ADDENDUM #2

Reference: Dixie State College
Miscellaneous Improvements
DFCM Project No. 05181640

Dixie State College of Utah
Campus Improvements
St. George, Utah

SHEET 1A101 & 1L101

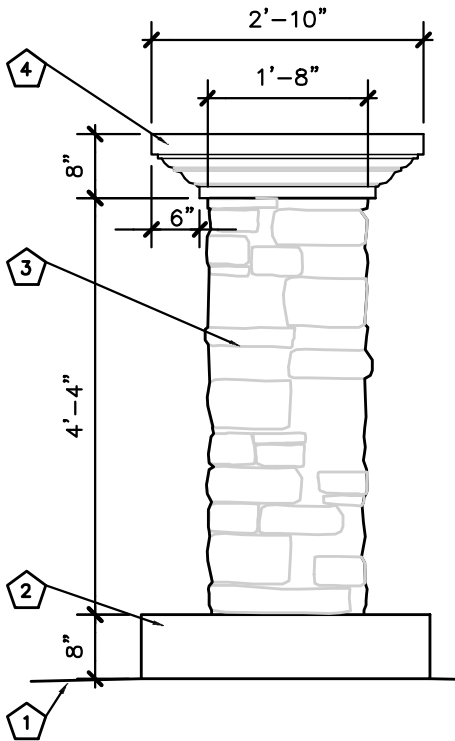
- ITEM #1 (Reference Drawing Sheet 1SP101 & 1L101)
Tie in new 1" main irrigation line at location shown (see attachment # 1) Run new line east as shown to new irrigation control valve box @ location shown. Water line at existing 1" meter has 145 lbs of pressure.

- ITEM #2 (Reference Drawing Sheet 1L101)
Drawing A1/1L101 shows irrigation controls inside building. Irrigation controls to be located out side building (see attachment #1)

- ITEM #10 (Reference Drawing 1SP101)
Provide (2) 20 amp, 120 volt, single pole circuit breakers in existing A/C electrical panel. Extend 3/4" conduit with (2) #12 thhn/thwn cu. and 1 #12 ground for each circuit to a weatherproof junction box located adjacent to campus sign. Provide Final electrical connection to sign. (See attachment #1)

SIGN ELEVATION

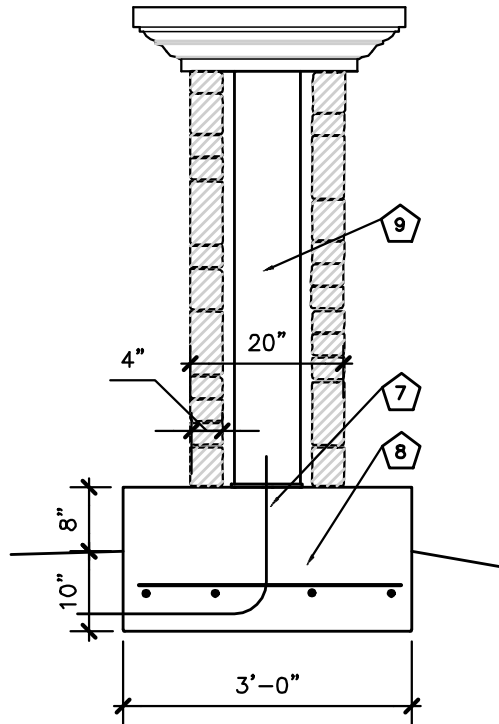
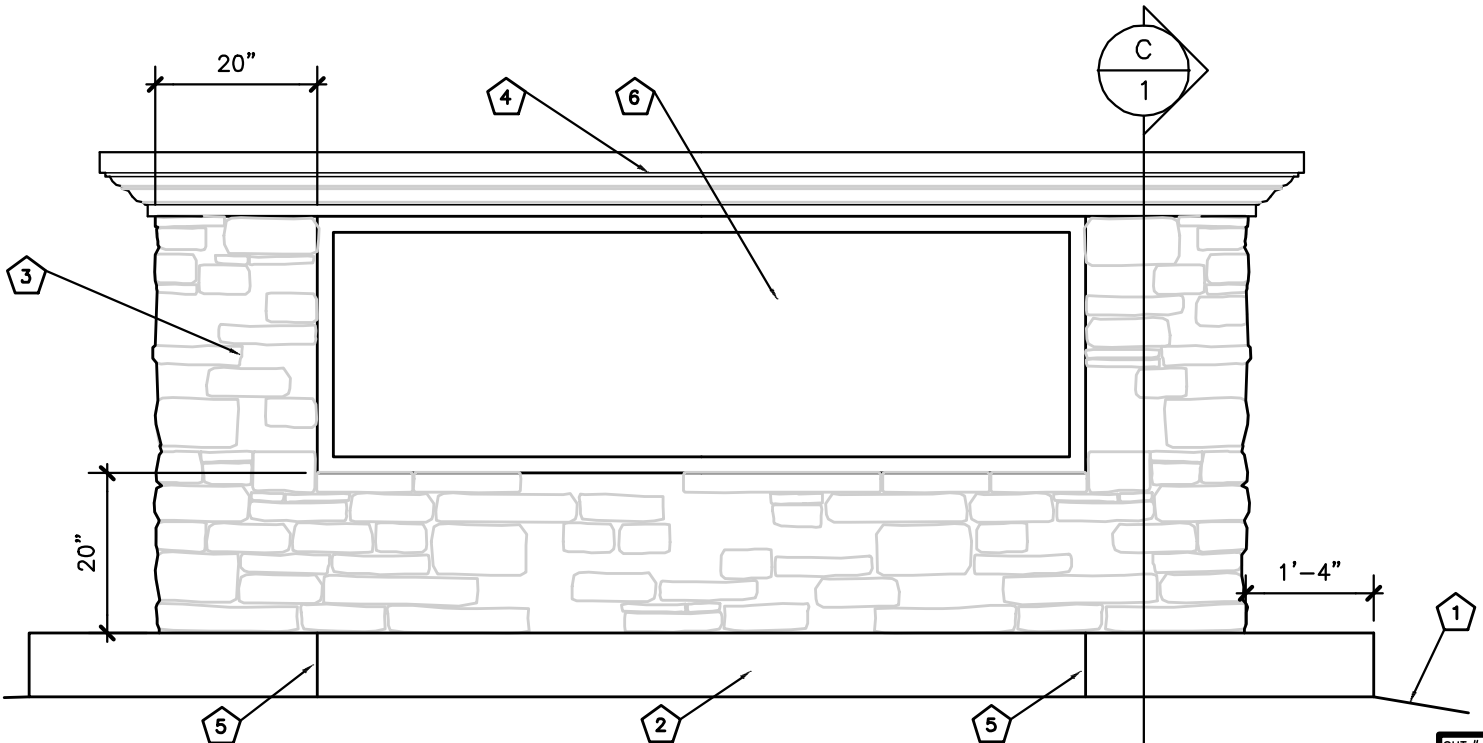
- ITEM #8 (Reference Drawing 1SP101)
Add college sign to bid. (See attachment 2) (See attachment 1 for sign location) This sign to be the same type sign as located at the Administration Building.

- 1 FINISH GRADE
- 2 CONC. BASE
- 3 4" THICK SANDSTONE ROCK, MATCH EXISTING ROCK AT ADMIN. SIGN.
- 4 PRECAST CONC. CAP - SIZE AS SHOWN-MATCH EXISTING SIGN AT ADMIN. FOR SHAPE AND COLOR
- 5 CONTROL JOINT IN FACE AND TOP OF BASE
- 6 ACRYLIC SIGN PANEL IN 2" THICK METAL FRAME TWO SIDES WITH INTERNAL LIGHT. GRAPHICS AS DIRECTED BY DIXIE COLLEGE
- 7 PROVIDE ELECTRICAL CONDUIT THROUGH CONC.
- 8 CONC. FTG. WITH #4 BARS @ 8" O.C. BOTH WAYS
- 9 SIGN STRUCTURE TO BE STEEL FRAME WORK ABLE TO SUPPORT CONC. CAP & ROCK VENEER SIGN SUPPLIER TO PROVIDE ENGINEERED DESIGN & SHOP DRAWINGS TO ARCHITECT.

H1 - 2A401, H5 - 2A401
D1, D4, D8, A4, SHT. 2A703

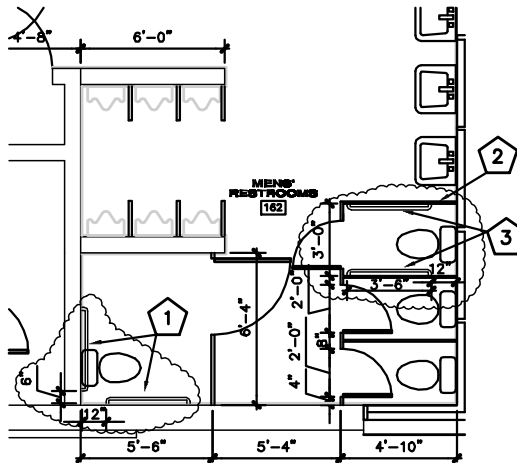
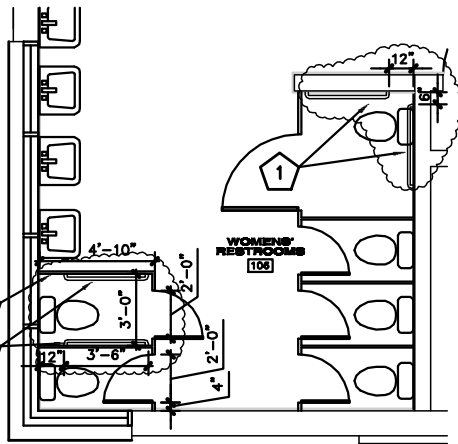
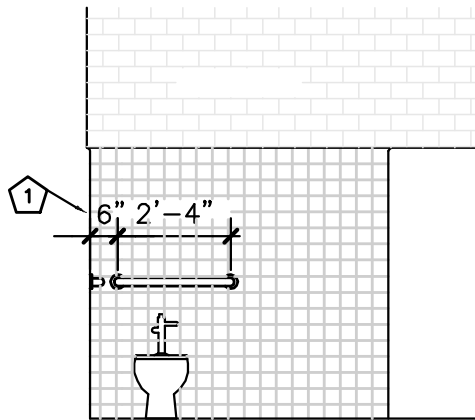
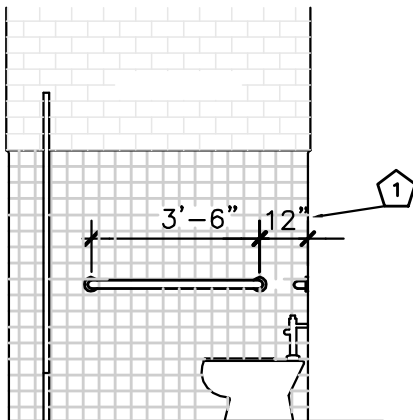
- ITEM #3 (Reference Detail H1/2A401 & H5/2A401 & Detail D1, D4, D8, A4 Sheet 2A703)
Provide new toilet partition in location shown (see attachment #3). Provide two grab bars as shown. Mounting height to be 34" off floor.

- ITEM #4 (Reference Detail H1/2A401 & H5/2A401)
Relocate existing grab bars in women restroom 106 and men restroom 162 to locations indicated (see attachment #3)

- 1 RELOCATE EXISTING GRAB BARS WITH DIMENSION FROM WALL INDICATED
- 2 SPACE TOILET PARTITION AS INDICATED
- 3 PROVIDE TWO 42" LONG GRAB BARS AS SHOWN
